Access Compliance Report

Public Rights-of-Way

(Curb Ramps)

Intersection ID: 29299	Main Street: WANDERING_CREEK_DR	Cross Street: MAJESTIC_MEADOW_DR	Location: SW
ADA ID: C92960A9806F	Ramp Type: Perp	Initial Pass/Fail: Fail	Overall Compliance: No
Severity Score: 10			
Codes/Mitigation Info/Possible Solution		Field Measurements/Component Compliance

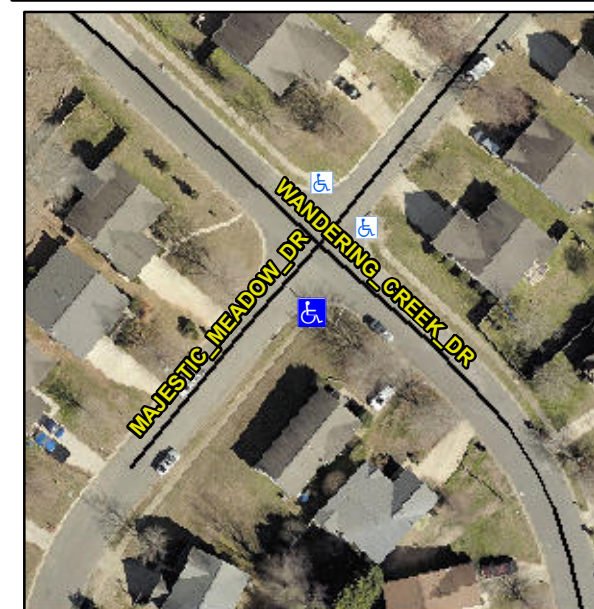
Not Found, R304.5.1

Compliance	Description	Data	Compliance	Description	Data
N/A	Ramp Length (in)	44.0	Yes	Ramp Slope (%)	8.1
No	Ramp Width (in)	43.0	Yes	Ramp XSlope (%)	3.1
N/A	Flare Type LT	N/A	N/A	Flare Type RT	N/A
N/A	Flare Slope LT (%)	N/A	N/A	Flare Slope RT (%)	N/A
N/A	Flare Traversable LT?	N/A	N/A	Flare Traversable RT?	N/A
N/A	Landing Length (in)	N/A	N/A	DWS Provided?	N/A
N/A	Landing Width (in)	N/A	N/A	DWS Contrast?	N/A
N/A	Landing Slope (%)	N/A	N/A	DWS Length (in)	N/A
N/A	Landing X Slope (%)	N/A	N/A	DWS Full Width?	N/A
N/A	Landing Curb? (Y/N)	N/A	N/A	DWS Offset (in)	N/A
N/A	Shared Landing?	N/A			
N/A	Gutter Ponding?	N/A	N/A	Gutter Slope (%)	N/A
N/A	Gutter Lip Ht (in)	N/A	N/A	Gutter X Slope (%)	N/A
N/A	Painted X Walk1?	No	N/A	Painted X Walk2?	N/A
	X Walk 1 Direction	To NE		X Walk 2 Direction	N/A
N/A	X Walk 1 Width (in)	N/A	N/A	X Walk 2 Width (in)	N/A
	X Walk 1 Slope (%)	2.3		X Walk 2 Slope (%)	N/A
	X Walk 1 X Slope (%)	5.2		X Walk 2 X Slope (%)	N/A

Remove & Replace Entire Ramp.
